# PROPOSED MINOR PROJECT MODIFICATION

<b>Minor Project Modification Number:</b>	020	<b>Date:</b>	11/25/2025
<b>Project Title and Number:</b>	Biosolids Digester Facilities Project		
<b>Entire code:</b>	CWW SIPDP01: R24 - CM Environmental Construction Compliance - Biosolids Digester Facility - [10015796: 0001    20720    232146]		
<b>EP Case No. and Date</b>	2015-00644ENV		
<b>SFPUC Original Approval Action and Date:<sup>1</sup></b>	Public Hearing, 3/13/18	<b>SFPUC New Approval Action for Modified Project:</b>	Administrative
<b>Prepared By:</b>	Dorinda Himes, BDFF Environmental Compliance Manager		
<b>Triggered By:</b>	<input type="checkbox"/> Value Engineering Change Proposal	<input type="checkbox"/> Project Change Order	<input checked="" type="checkbox"/> Other: SFPUC
<b>Landowner:</b>	<input checked="" type="checkbox"/> SFPUC <input type="checkbox"/> Other:		
<b>Vegetative Cover/Land Use:</b>	Paved	<b>Net Acreage Affected: Approx. 3,100 SF</b>

**FIGURE 1**  
**MPM-20 PG&E Natural Gas Meter Station & Underground Pipeline Vicinity Map**

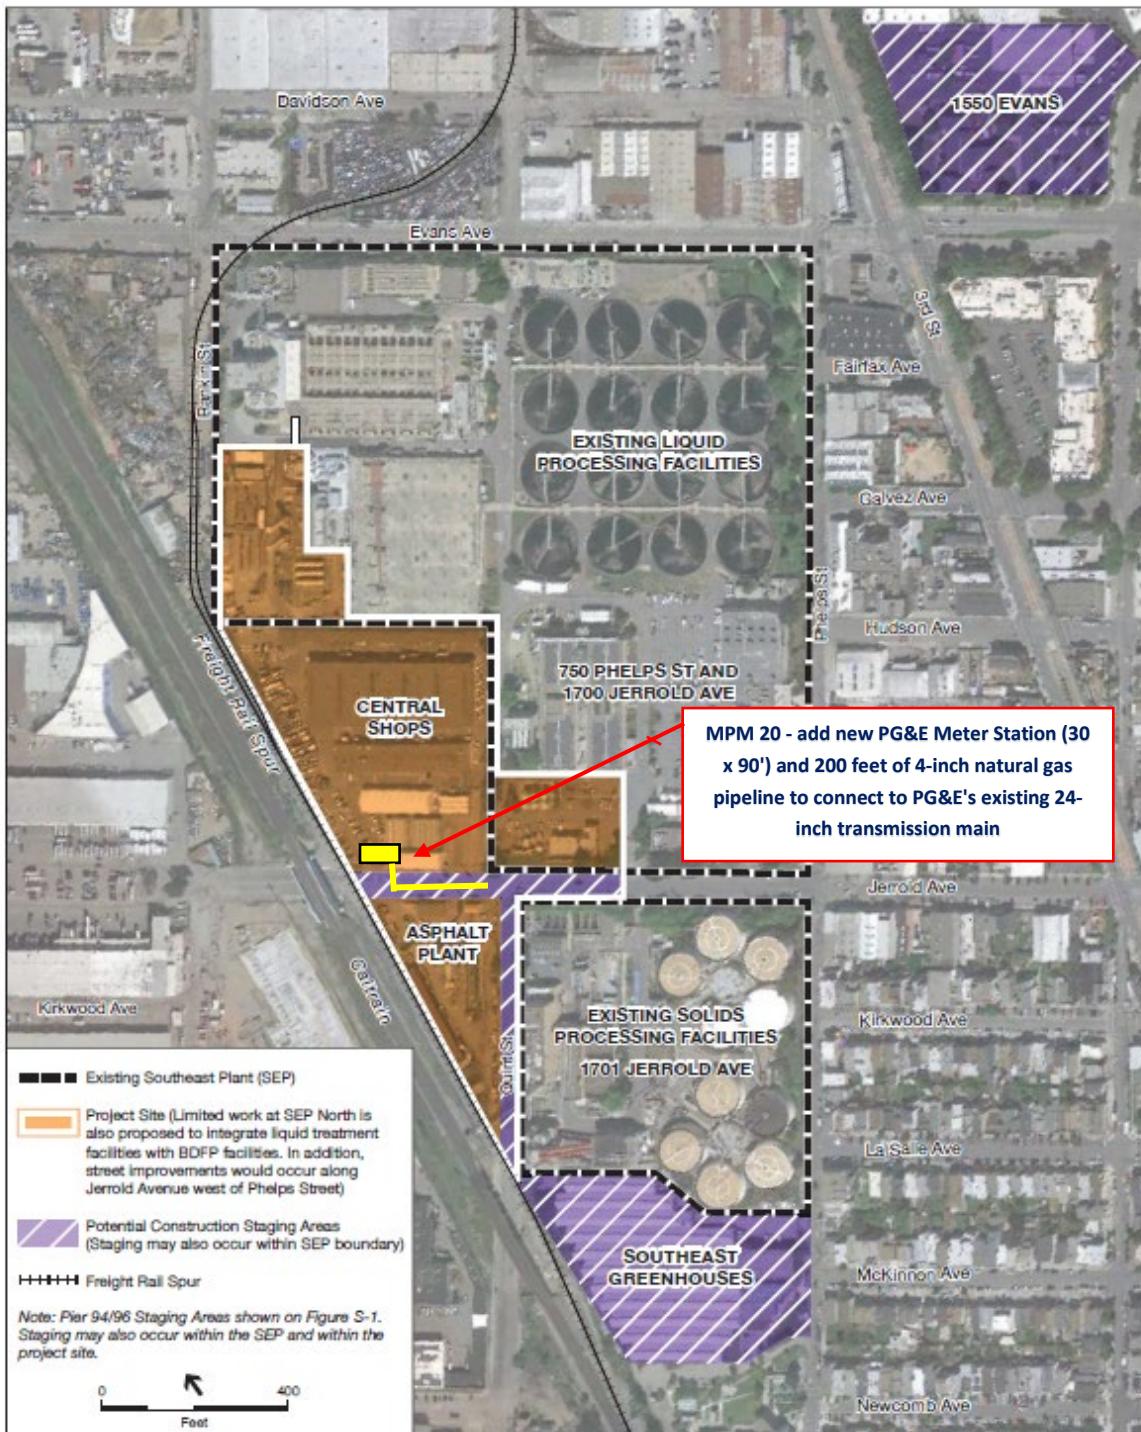
The SFPUC is requesting this modification to install the new 30 ft x 90 ft meter station within the SEP and within the BDFF project boundary (Figures 1 and 2). There would only be aboveground piping (no buildings) and the piping would rest on concrete pipe supports countersunk a few feet into the ground. The entire area would be paved. All piping would be a maximum of 4 feet tall. Piping would occupy about 20 percent of the meter station footprint while the remaining area would be open for parking and PG&E personnel use as needed. The meter station would be enclosed by a perimeter fence with two locked gates for access off Jerrold. Approximately 200 feet of new underground 4-inch diameter natural gas pipeline would be constructed from the meter station down Jerrold to connect the meter station to PG&E's existing 24-inch natural gas transmission main located at the corner of Jerrold Avenue and Quint Street. The trench would be approximately 2 feet wide and a maximum of 5 feet deep. Jerrold Avenue would be repaved and restored to preconstruction conditions. The new meter station and associated NG pipeline would be constructed and operated by PG&E.
